# PLAN COMMISSION STAFF REPORT

**Agenda Item:** PC 25-018

**Application Type:** Development Plan

**Summary:** Matt Kimmel is requesting consideration of a Development Plan for a single story, 4,200 SF financial institution, Chase Bank, within the Centennial Village Development and proposed to be commonly known as 9521 Calumet Ave.

Proposed SITE PLAN:

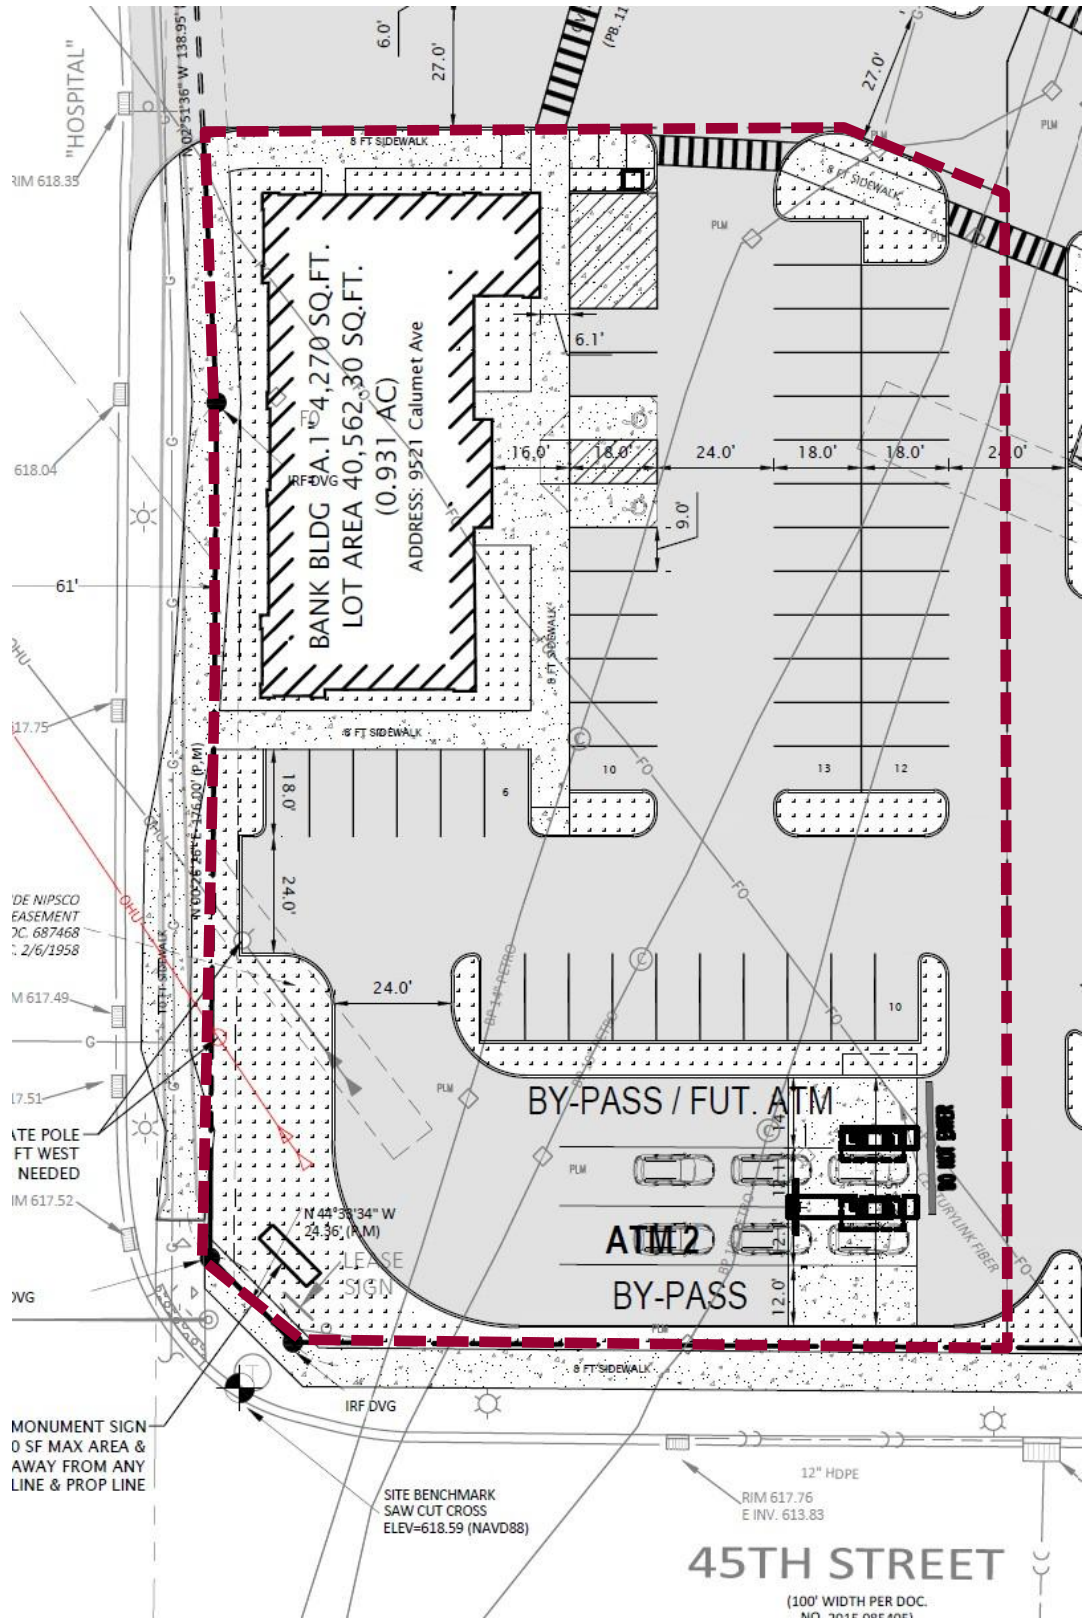
- Vehicle Parking = Required 76 Spaces (3.25 per GSF); Provided 127 including 5 ADA.
- Bicycle Parking = not identified
- Trees/Evergreens/Ornamentals = 25
- Building Materials = Brick, per PUD
- Lighting = Decorative per PUD
- Traffic = engineer's review of traffic impact report needed.
- Stormwater = Connection to existing development management system
- Subdivision/Replat of Lot C to create proposed Lot 10 for Sprouts Market (PC 25-015)
- Amendment to the Centennial Village PUD (PC 25-016)

At the October 14, 2025 Preliminary Hearing, the Commissioners found that the proposed structural materials comply with the Design Guidelines. However, they raised questions regarding the proposed location of the ATM facility at the corner. The applicant explained that the area contains underground pipelines, which restrict above-ground construction. Commissioners also discussed whether additional landscaping or a monument structure that may help screen vehicle stacking. The application was subsequently tabled pending review of the traffic study report from the engineers and analysis of the proposed roundabout's potential impacts.

Staff finds that the applicant has properly submitted a complete application with all required supporting documents. Also, as discussed during the Commission's review, staff supports the inclusion of a more robust screening measures for the bank's vehicle stacking area be presented as part of the Public Hearing process. Perhaps raised landscape mound or architectural gateway wall may accomplish screening efforts. Finally, staff recommends that the applicant ensure compliance with Section 26-6.804.L.9.k.xii regarding Public Notice requirements and review Section 26-6.804.L.9.k.xiii.I–XII governing the Public Hearing procedures under the Town of Munster Character-Based Zoning Code.
